CHANGE ORDER

Construction of Barbara Jordan Park Community Center, 8705 Park Street, Needville, Texas 77461
Bid No. 25-025

CHANGE ORDER NUMBER: 1
DATE: 12/05/2025
BID NUMBER: 25-025
CONTRACT FOR: Construction of Barbara Jordan Community Center
CONTRACT DATE: 1/28/2025
FBC PURCHASE ORDER NO. 253107

CHANGE PROPOSAL NO.: 1 R10

Drawing Name
**ARCHITECTURAL
OVERALL
SITE PLAN
AS-100**

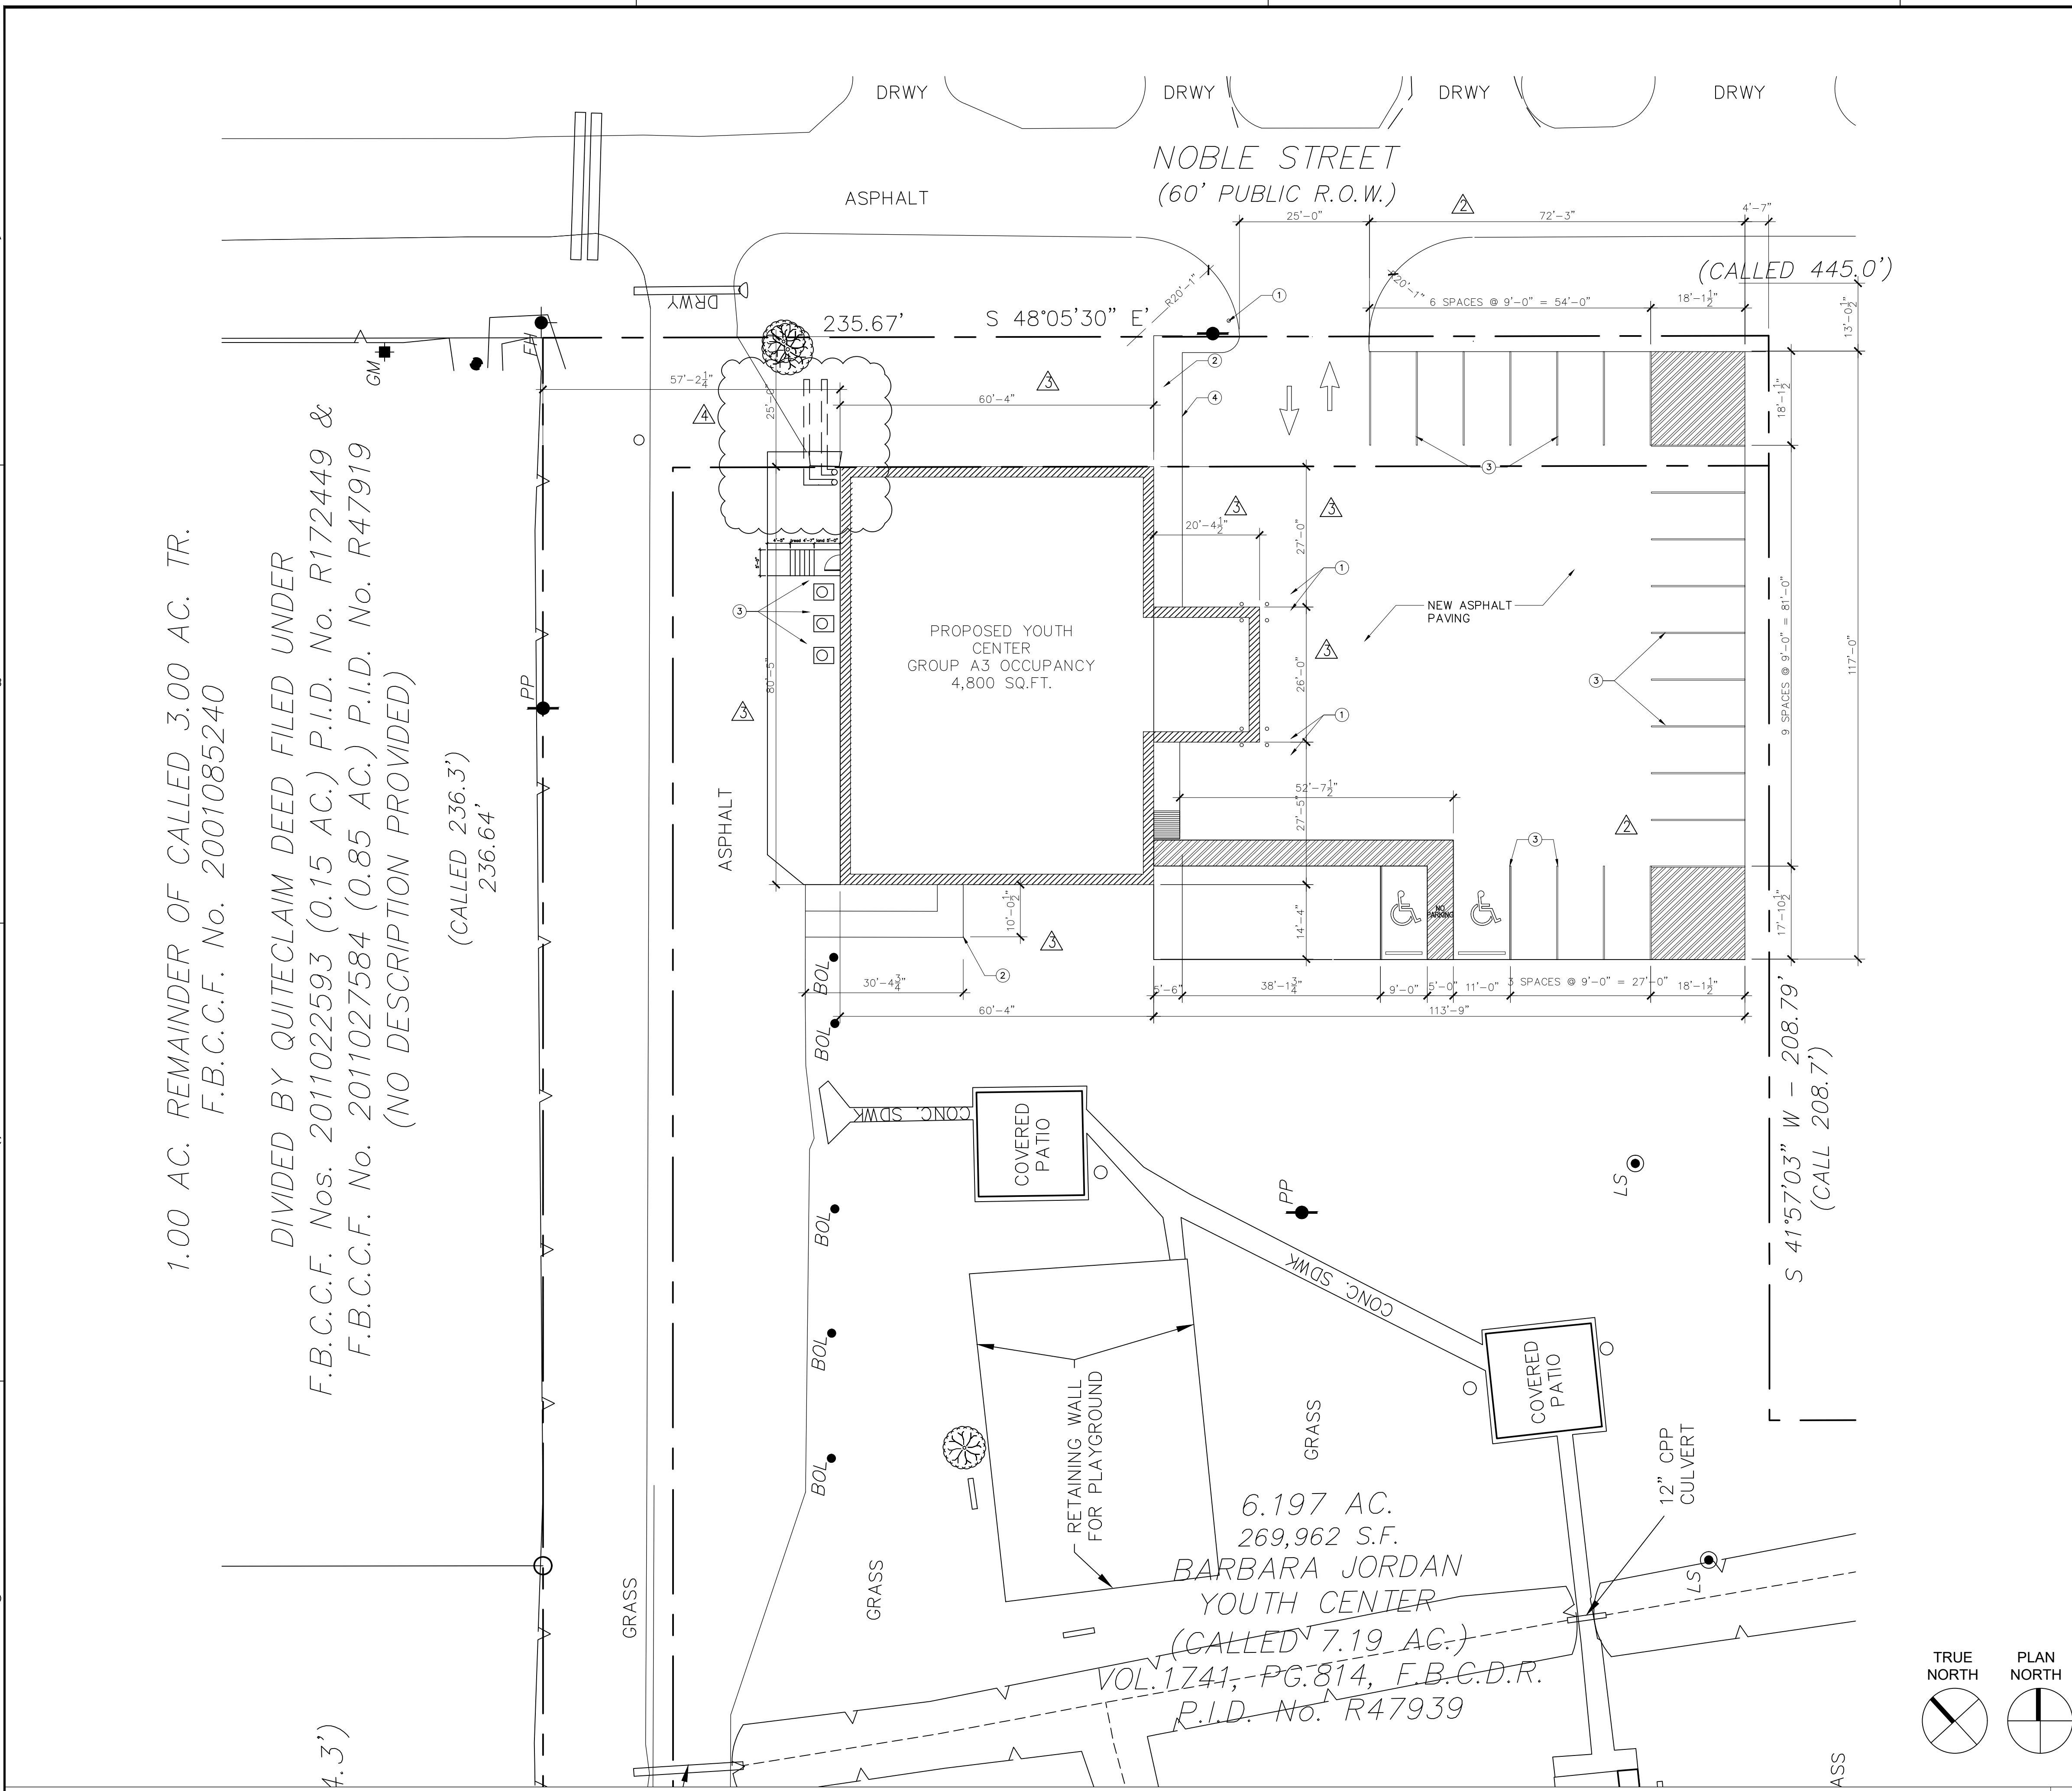
SYMBOL	DESCRIPTION
①	8" DIA. PAINTED STEEL BOLLARD
②	5'-0" WIDE CONC. SIDEWALK
③	EXTERIOR TRAFFIC PAINT STRIPING
④	6" CONC. CURB
⑤	MECHANICAL CONDENSING UNITS, RE: MECHANICAL FOR ADDITIONAL INFORMATION
⑥	ADD (2) 4" PVC CONDUIT FOR FUTURE LOW VOLTAGE WIRES
⑦	
⑧	
⑨

Drawing Name
ARCHITECTURAL OVERALL SITE PLAN
AS-100

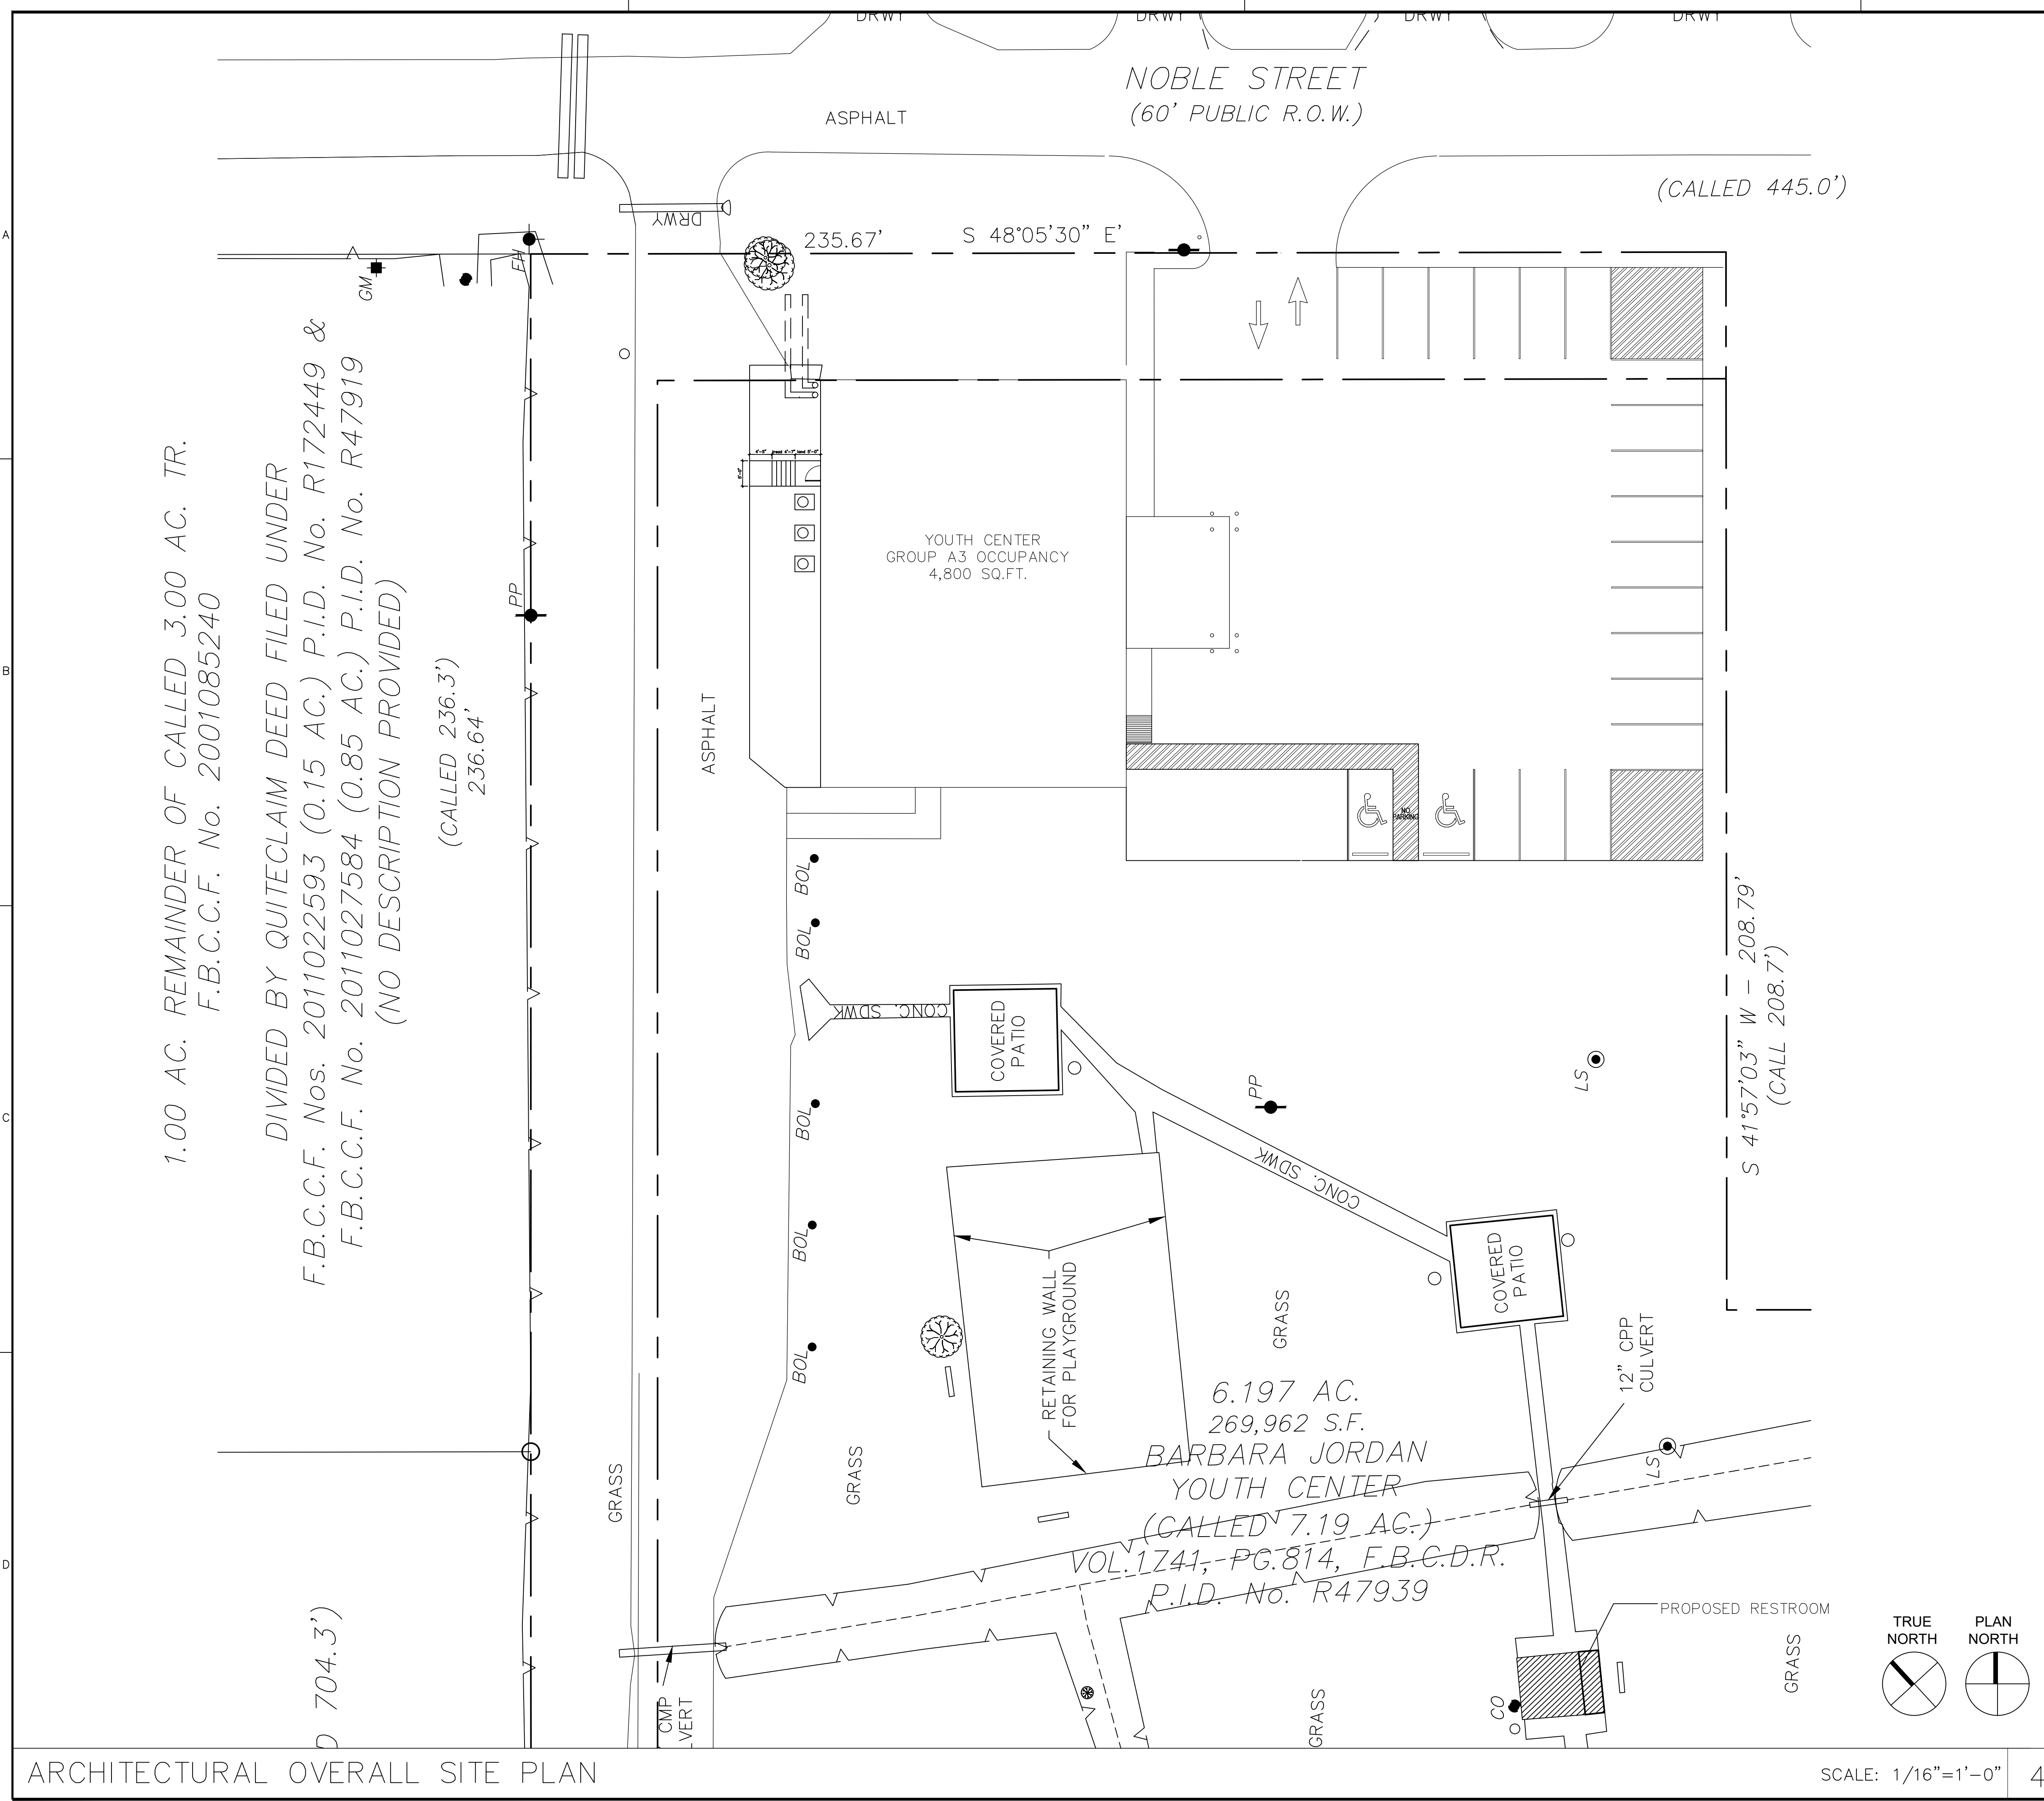
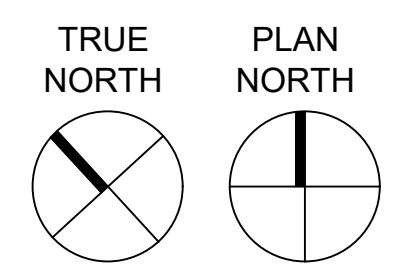
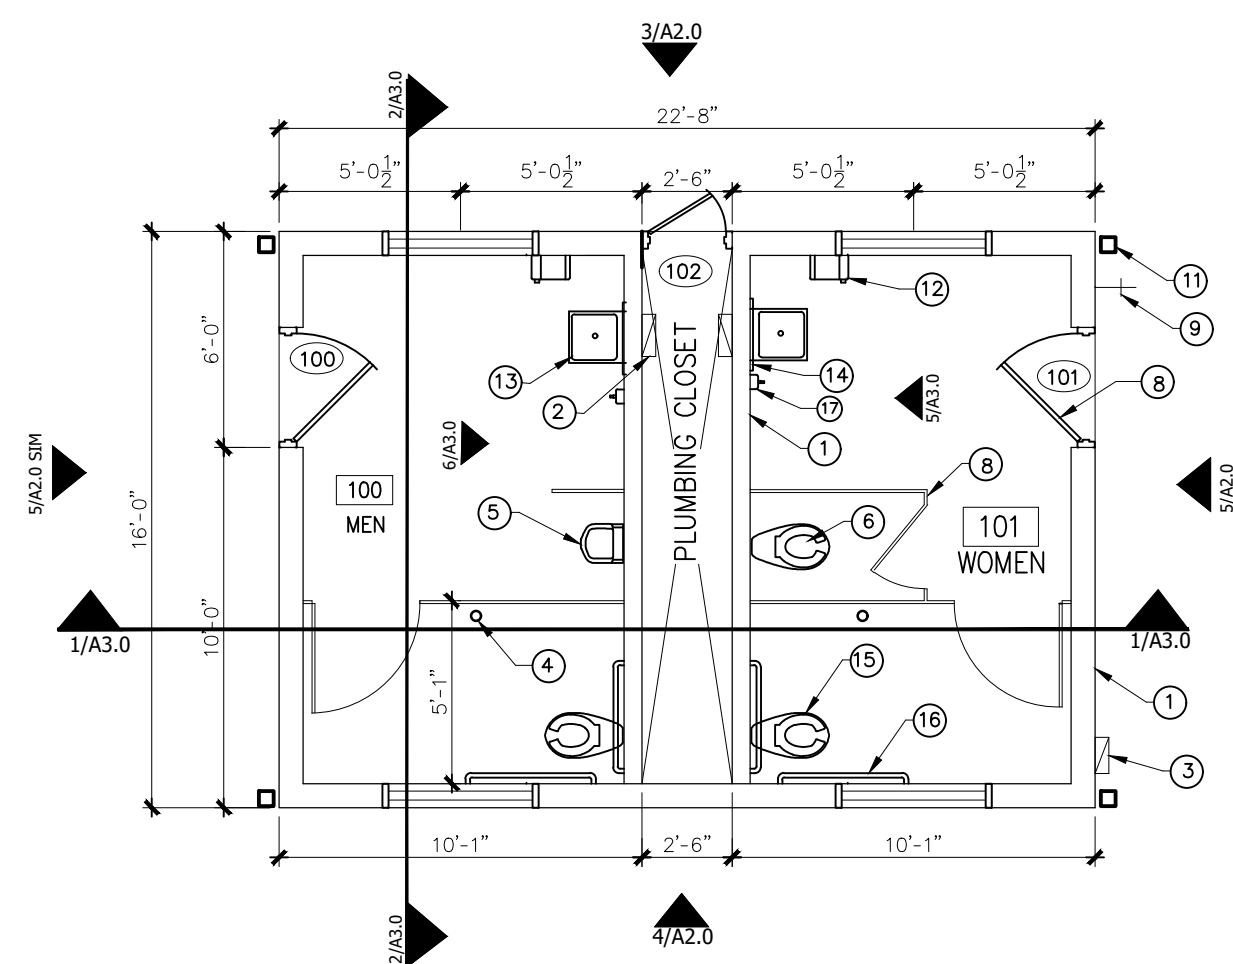
DESCRIPTION	DATE
ISSUE FOR BID AND CONSTRUCTION	01/5/2024
RFI #1	03/6/2025
CPR#2 LANDSCAPE ALLOWANCE	05/25/2025
12/5/25 RESTROOM ADD
